Correspondence Reference Number: 19872 Reply

731 Confirmation Number: EA101138

FCC ID: NWJ10A007A

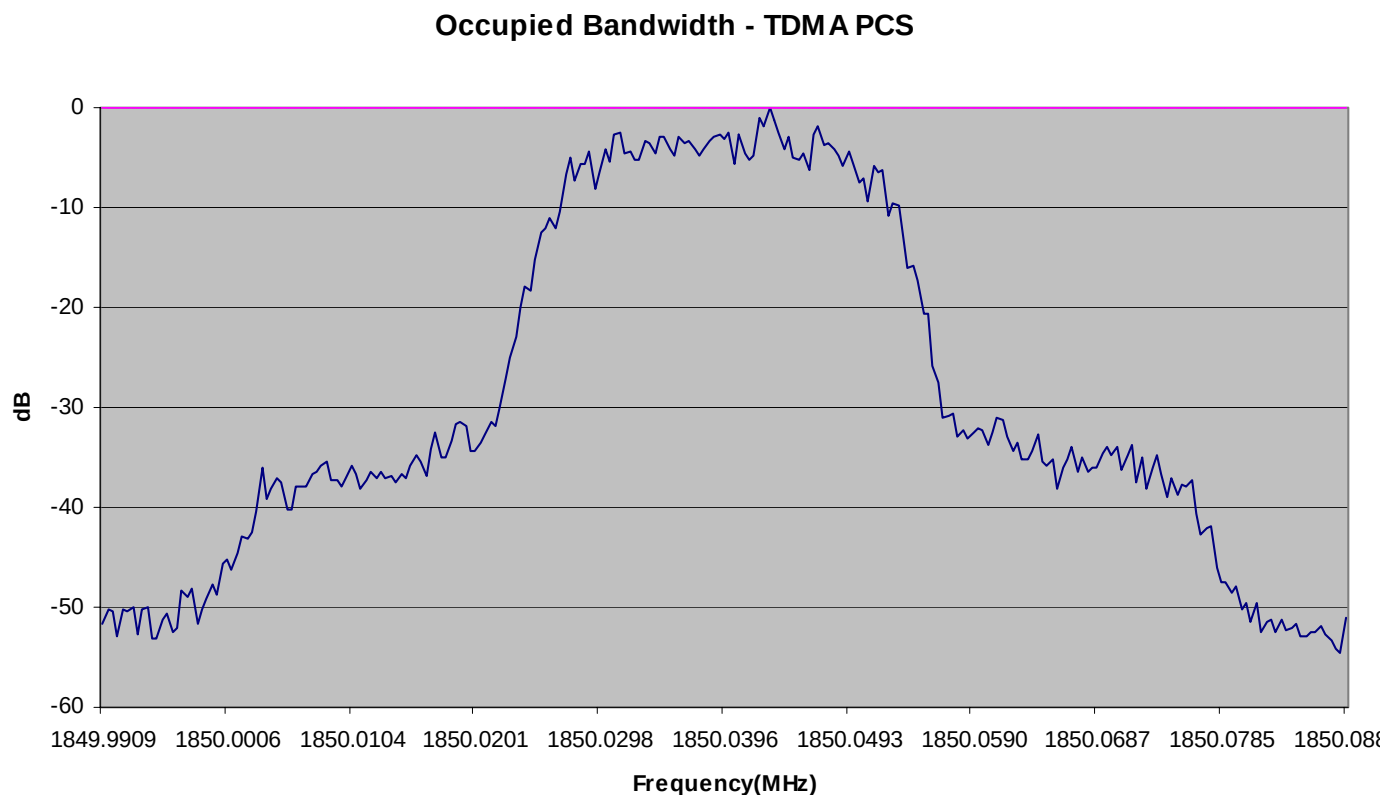
- 6.) Please provide occupied bandwidth measurements for the PCS operation to justify the 256K values listed on FCC Form 731.

Following is a plot of this data.
